Lucas Oil Pro Pulling League

2020 Rule Changes

Update #2

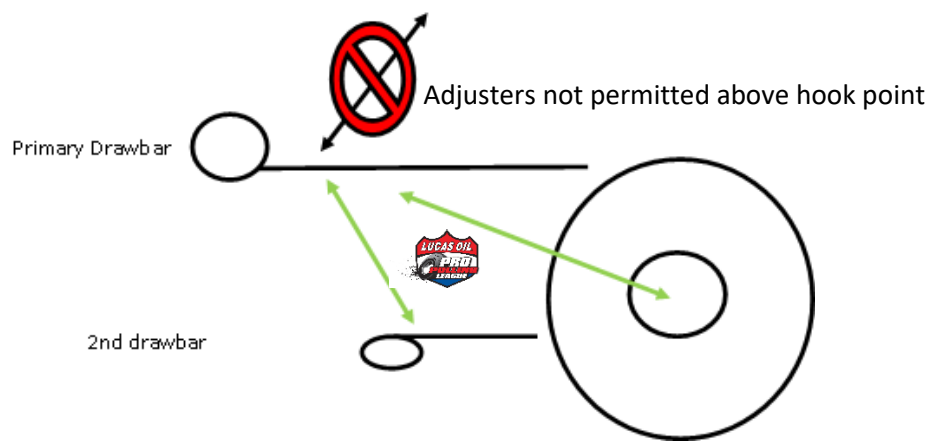
The OEM chassis is mandatory. The vehicle must retain a full $\frac{3}{4}$ or 1-ton size chassis. Wheel tubs, back-half conversions, tube chassis prohibited. Maximum wheelbase 158" and 102" maximum width. (outside tire to outside tire). Rigid suspension allowed. Hydraulic steering permitted. (Intent= no Isuzu or compact diesel chassis)
